## COMMITTEE OF EXPERTS ON THE TRANSPORT OF DANGEROUS GOODS AND ON THE GLOBALLY HARMONIZED SYSTEM OF CLASSIFICATION AND LABELLING OF CHEMICALS

### MISCELLANEOUS PROPOSALS OF AMENDMENTS TO THE MODEL REGULATIONS ON THE TRANSPORT OF DANGEROUS GOODS

Impact testing of UN Portable tanks and MEGCs

Proposal to change Sections 6.7.2.19.2, 6.7.3.15.1, 6.7.4.14.1 and 6.7.5.12.1

**Figure 1: Minimum SRS Curve**

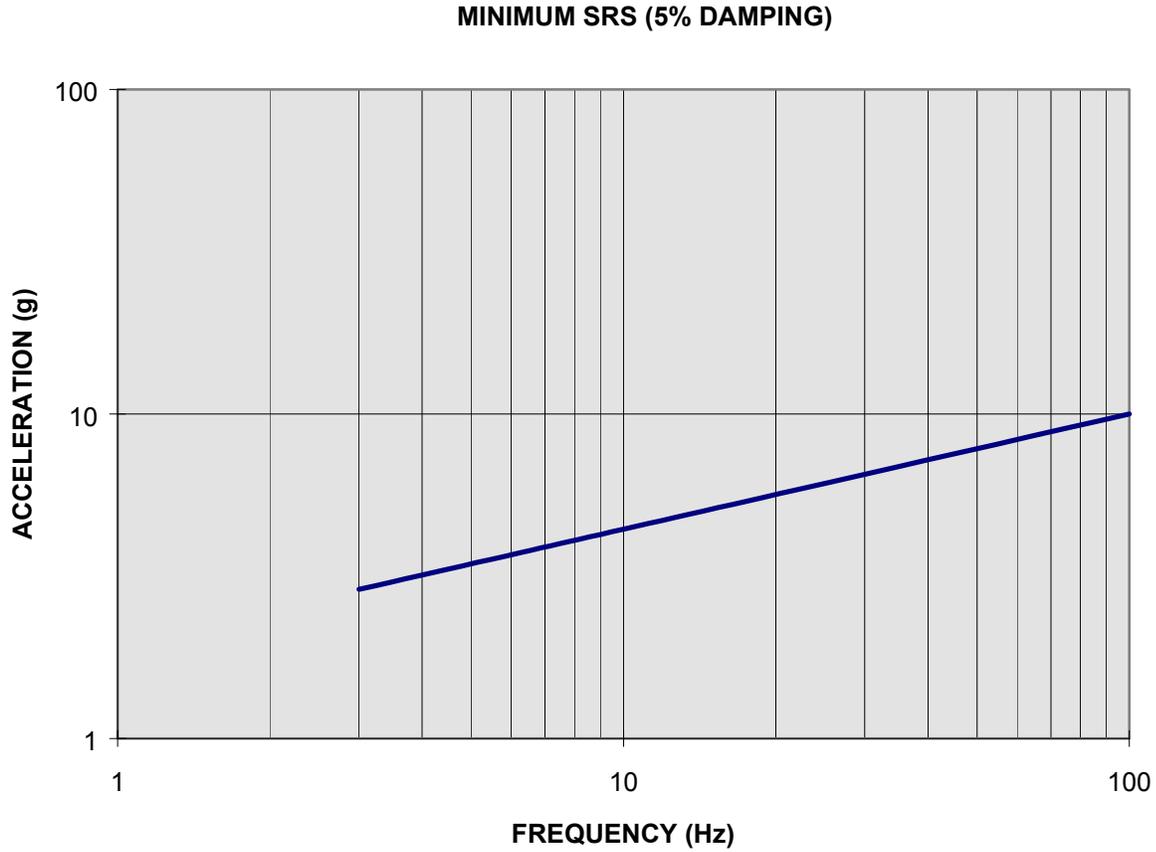
3.4.4 Create an impact (see section 3.2) such that for a single impact the as tested Shock Response Spectrum (SRS) curve at both corner fittings equals or exceeds the minimum SRS shown in Figure 1 at all frequencies within the range from 3 Hz to 100 Hz. Repeated impacts may be required to achieve this result;

Equation for generating the above Minimum SRS Curve:  $ACCEL = 1.95 \text{ FREQ}^{0.355}$
